National Forensic Mental Health Service Hospital, Portrane, Co Dublin

Planning Submission to An Bord Pleanala in Respect of An Bord
Pleanala Ref. No. 06F.PA0037

Waterman Moylan Consulting Engineers Limited

Client Name: Various respective Community Groups (part of the Community Working Groups Forum of Donabate / Portrane)
Document Reference: 15-052r.001
Project Number: 15-052

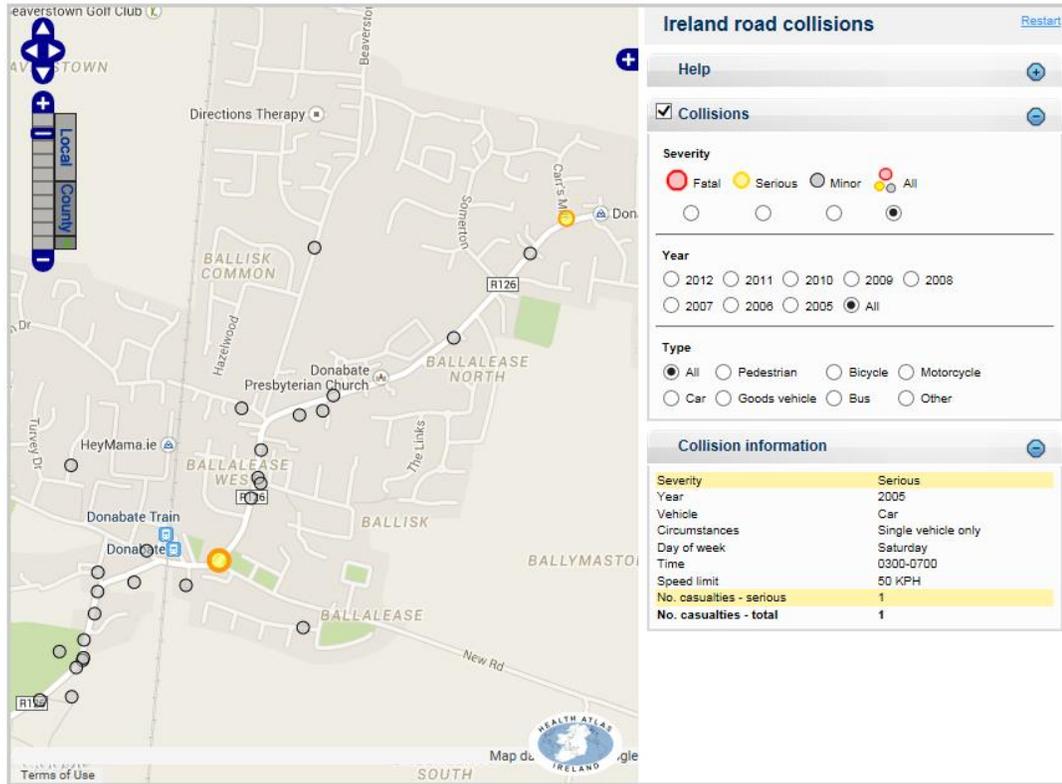
The **traffic collision** data for this area is readily available from the Road Safety Authority. From examination of this data, a road fatality occurred at the proposed site access junction (Portrane Avenue / R126) in 2010 and a minor road collision was recorded along Portrane Avenue within the St. Ita's Complex . see below

In the period 2005-2012, 12 No. collisions were recorded on or adjacent the 300 m of the R126 west of the railway humped back bridge, with a further 13 No. collisions recorded on the R126 east of the railway bridge, including 2 No. serious collisions . see extract below
